Identifying UNDERHOOD™140cfm and 150cfm Clutch for Replacement

UNDERHOOD™ 140cfm and 150cfm – Compressor Serial Number starts with P140xxxxxxxx.

Figure 1

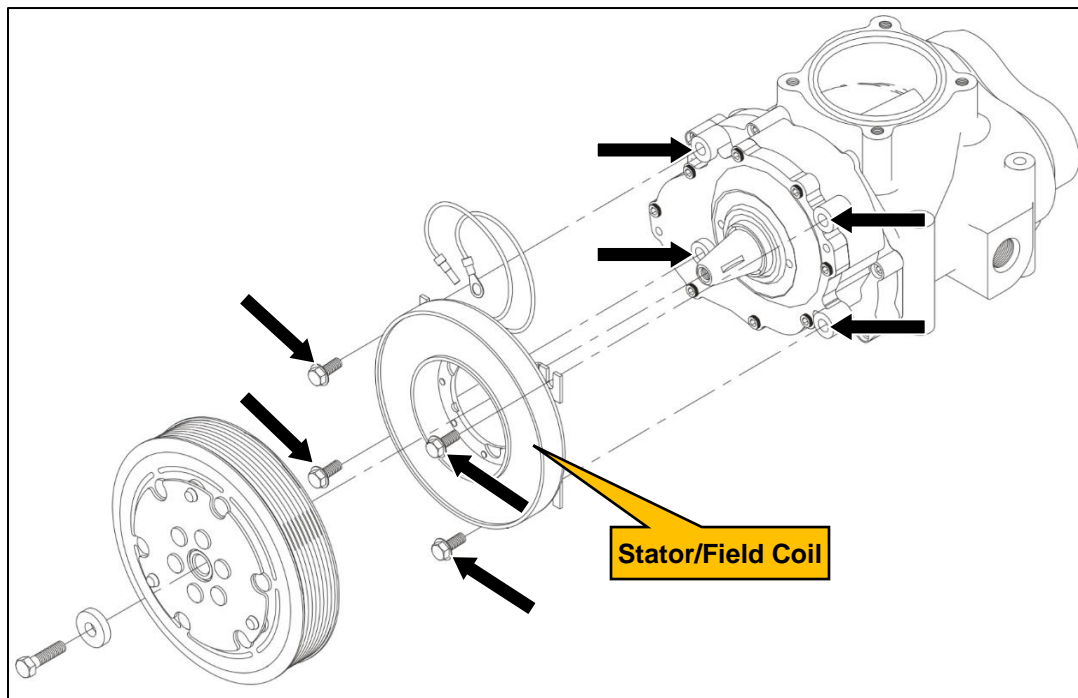
Obsolete clutch with 4 bolt stator mount (P/N: P200039):

- The P200039 is identifiable by the 4 bolts holding the clutch stator/field coil to mounting points on the front gear case cover of the compressor. See *Figure 1*.

If a replacement clutch is required for a UNDERHOOD™140 / 150 with the old-style clutch, order kit number A700234, which contains the new-style P200050 clutch and an updated front gear case cover assembly.

Figure 2

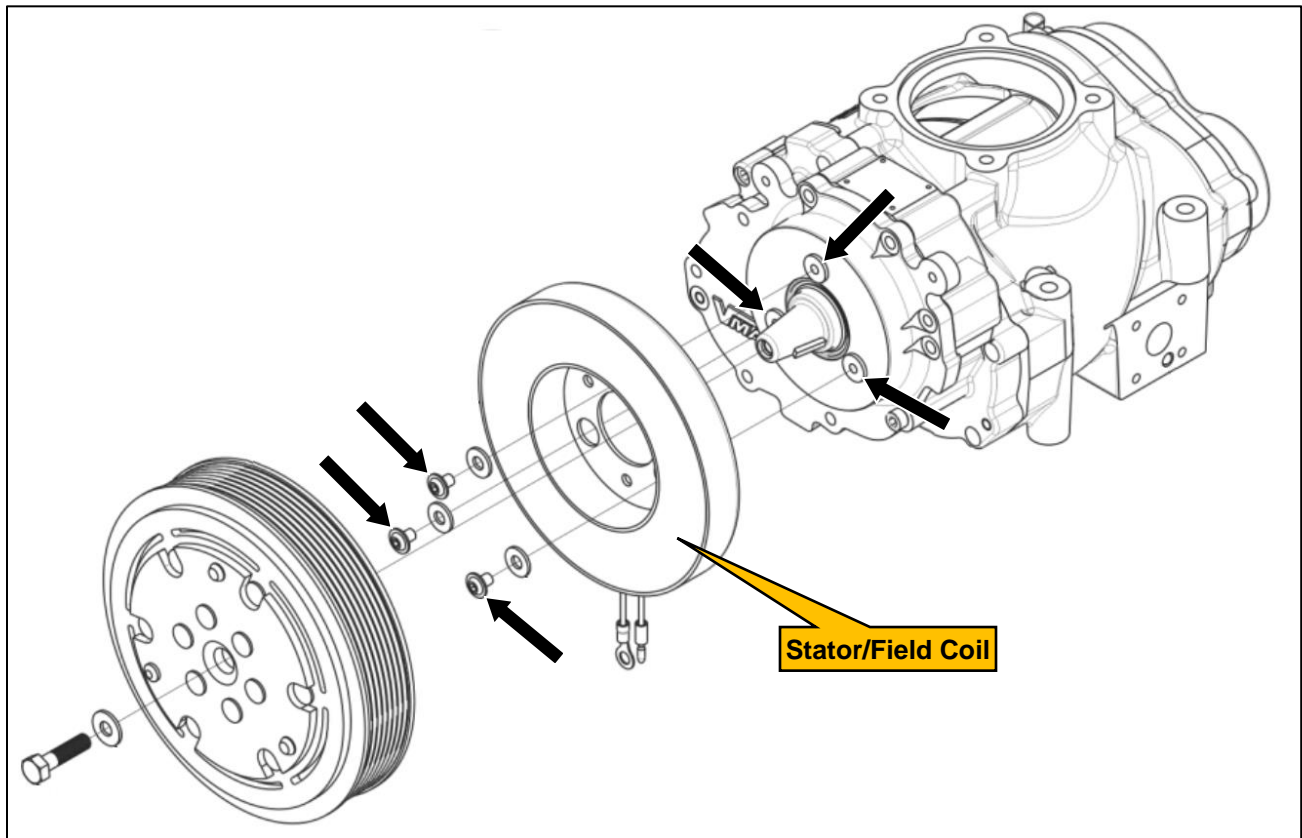
New-Style P200050 clutch with 3 bolt stator mount:

- The new design P200050 clutch is fastened to the compressor gear case using 3 bolts inside the clutch stator. These bolts are not visible when the clutch is assembled. See Figure 2.
